REPORT - MEETING No. 10

INDEPENDENT GEOTECHNICAL REVIEW BOARD (IGRB)

Review of Water Dam, Water Management and Tailings Management Facility, KSM Project

British Columbia, Canada

Figure 1 Dam Components

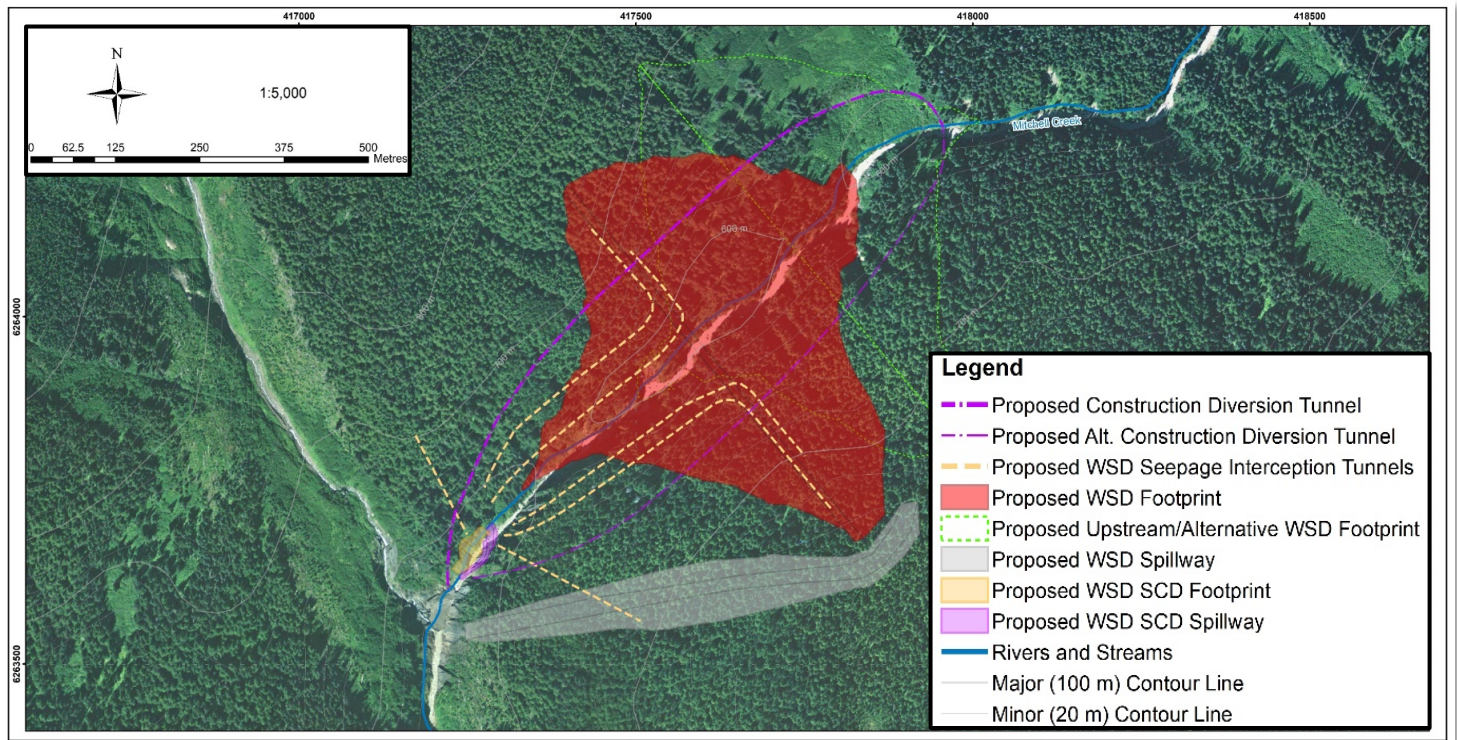
Consideration should also be given to enhancing the grouting program for WSD if necessary, by extending the length of the galleries (which are part of the Seepage Collection Tunnels shown on Figure 1) along the dam axis in both abutments, especially on the left abutment, to enhance the efficiency of the grouting curtain and the seepage collection system.

- *Consider long horizontal borehole drains at the SCD that could be used to supplement the proposed Seepage Interception Tunnels or as an alternative to these two tunnels (Figure 1). Open pit wall depressurization is likely to require installation of horizontal drains, and the use of the same drilling rig could be cost and schedule competitive to construction of seepage interception tunnels. In considering such boreholes, the installation and long-term maintenance or replacement requirements will need to be addressed.*

Figure 3 Hydrogeologic Section A-A' Through the WSD

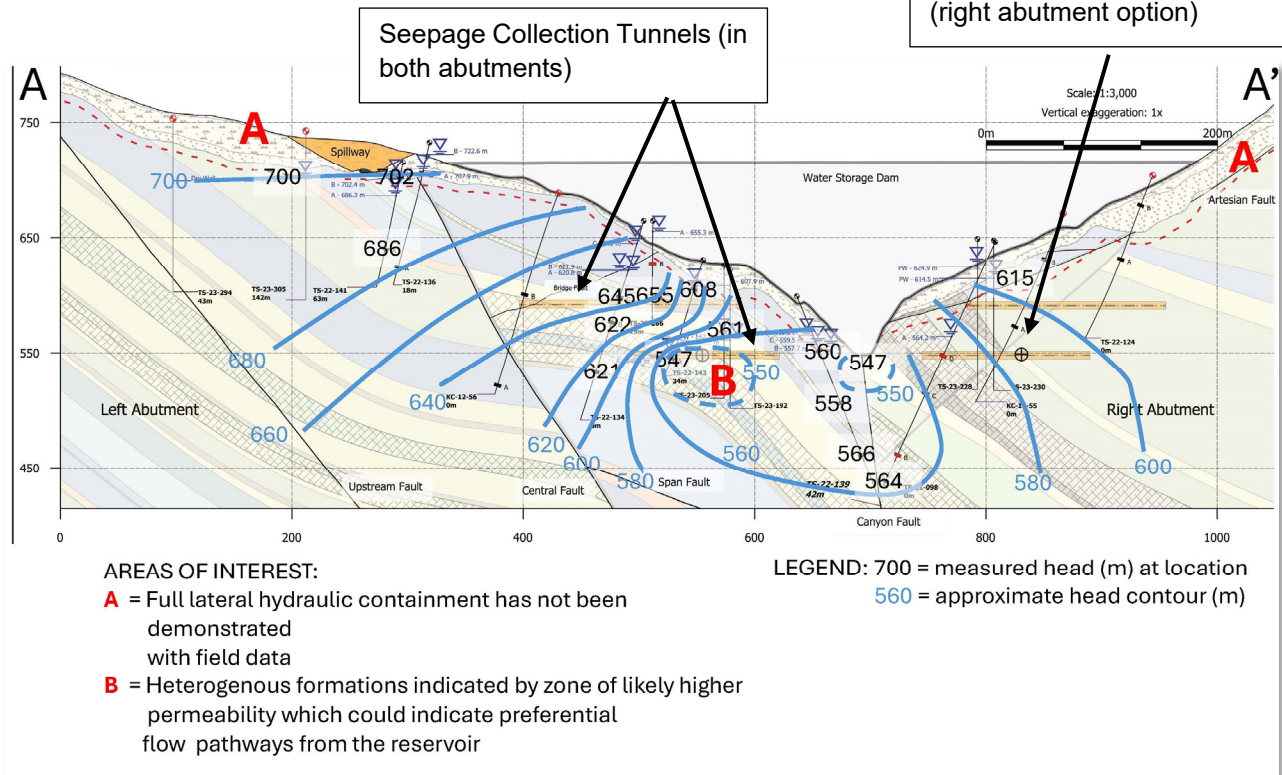
- On Section A-A' through the WSD (Figure 3):

Area A: Full lateral hydraulic containment on the upper left and right abutments has not been demonstrated. On the left abutment, the highest hydraulic head measurements are approximately 700 masl, below the spillway invert level of 706 masl. No measurements are available on the upper right abutment.

Area B: Heterogenous formations are indicated by an apparent zone of lower head and higher permeability approximately 100 m below the surface and in the left abutment, which could indicate preferential flow pathways out the impoundment behind the dam.

In planning future additional field investigations and testing as mentioned in Section 8 of this Report, a specific focus should be on determining the extent of natural hydraulic containment around the impoundment areas behind the dams as well as designing the elements (e.g. grout programs, drainage tunnels, etc.) necessary to achieve the high degree of containment required by the project permit.

Figure 4 Hydrogeologic Section E-E' Through the Left Abutment of the WSD

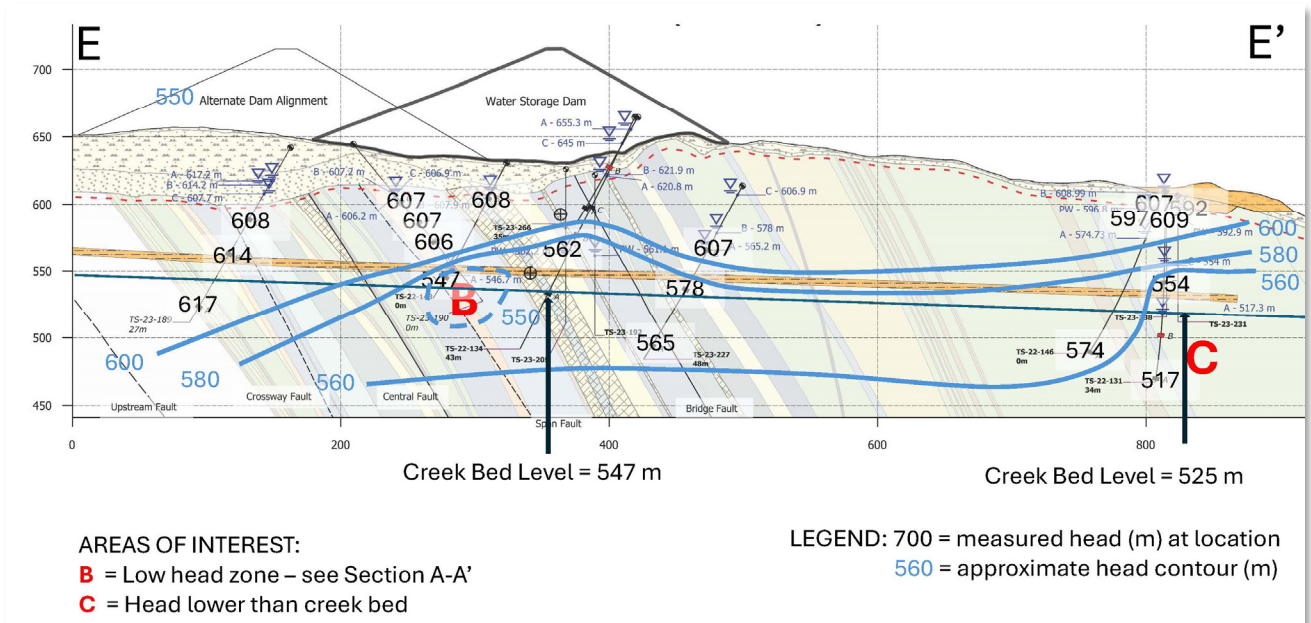
- Section E-E' in the Left Abutment (Figure 4):

Area B: The same low hydraulic head zone in Figure 2 appears on this section as well.

Area C: Of note, is that the total pressure head in this area 150 m below the surface is lower than the creek bed indicating a higher permeability zone draining groundwater to further downstream.

Figure 5 Hydrogeologic Section F-F' Through the Right Abutment of the WSD

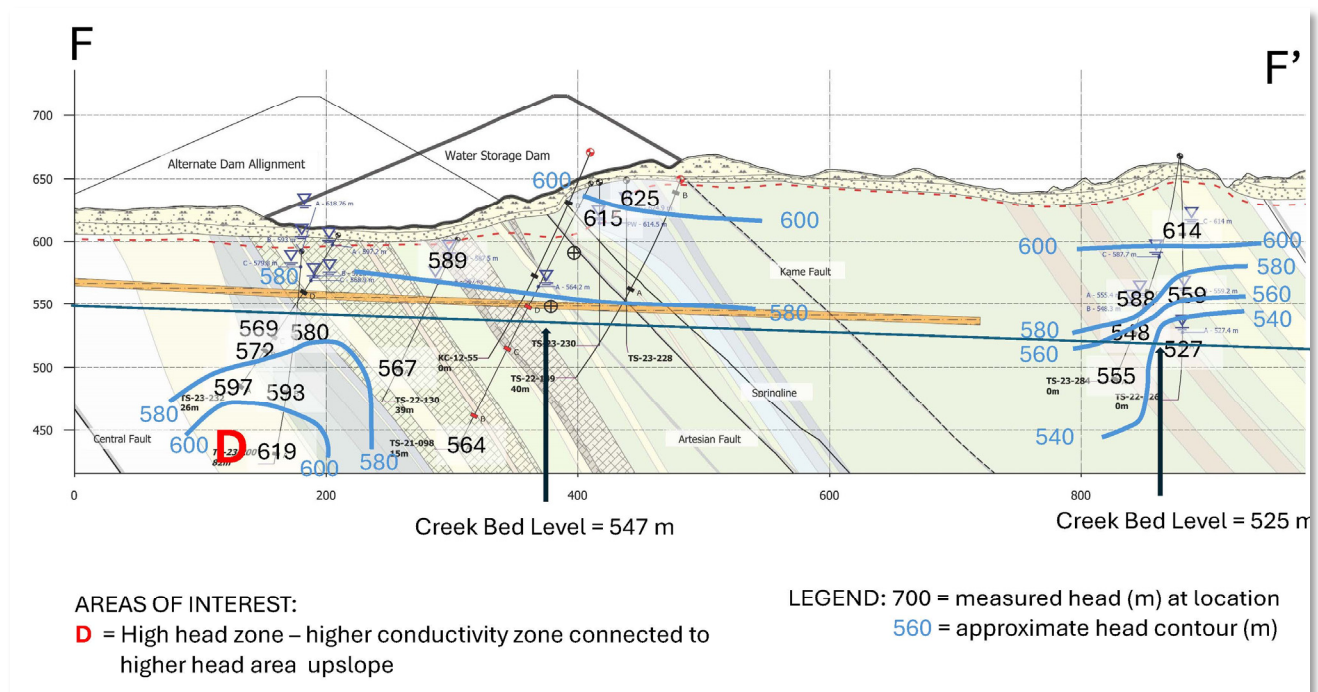
- Section F-F' in the Right Abutment (Figure 5)

Area D: In contrast to the above, this section exhibits a high total pressure head zone and upward gradient approximately 100 m below the upstream toe of the WSD. A higher conductivity zone may be connected to a higher head area upslope causing this condition.

Figure 6 Packer Testing Hydraulic Conductivities.

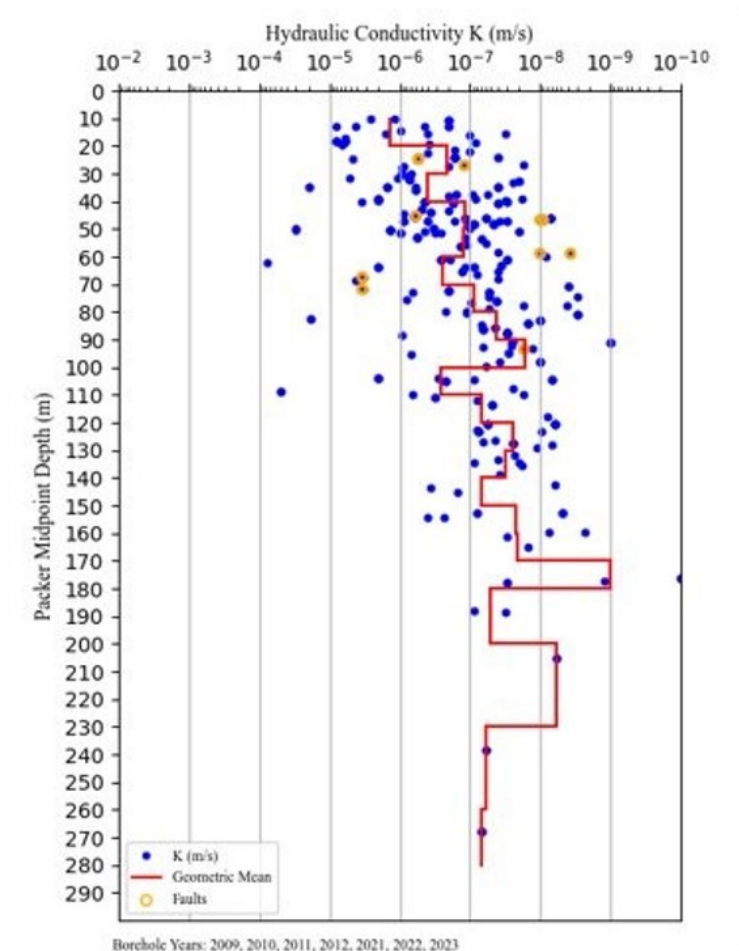
- *The available permeability data has been plotted against depth to identify statistical trends which are typically seen in most similar rock masses and are used, for example, to define the required depth of a grout curtain (Figure 6). Since the site includes a range of different stratified formations with varying degrees of tectonic and extents of weathering, the data needs to be filtered to eliminate data with poor confidence levels and should also be presented by geologic formation and structural zone to depict any differences in the permeability of these.*

Figure 7 WSD Stereo Nets

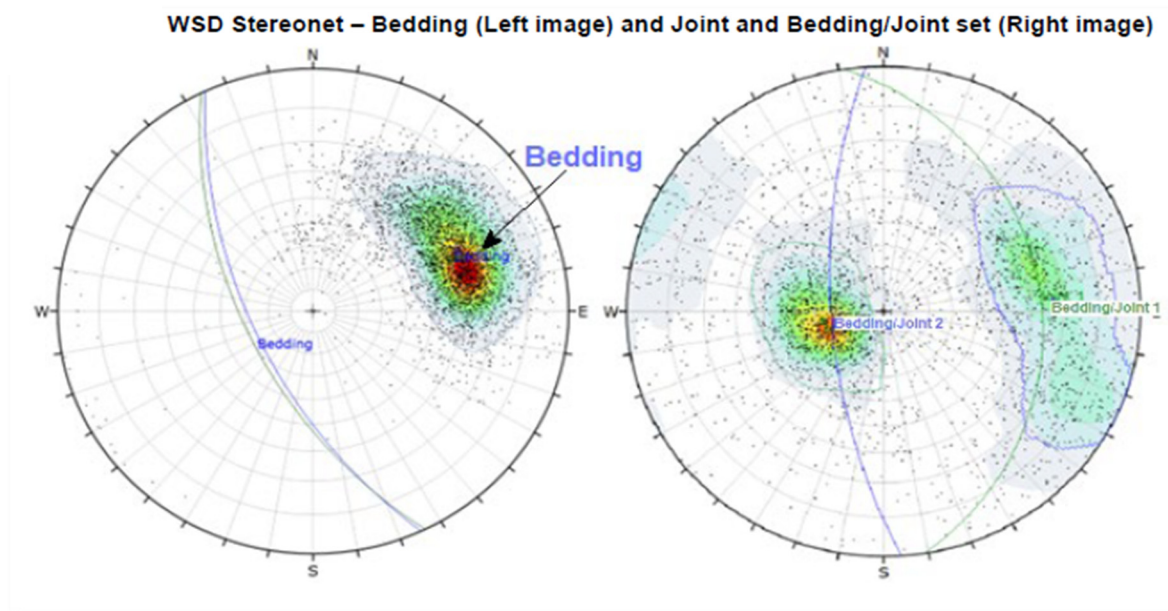
The WSD will be constructed on a prepared foundation. The plinth and core will be founded on bedrock. Bedrock bedding (Figure 7-left image) appears favorably oriented for dam stability. Identified faults dip steeply and appear favorably oriented for dam stability (Figure 8). The bedding/joint Set 1 (Figure 7-right image) is key to both the dam's stability and the stability of foundation preparation excavations.

The effect of the bedding/joint Set 2 on dam stability and the stability of any excavations of the dense till overlying bedrock will need to be evaluated and documented.
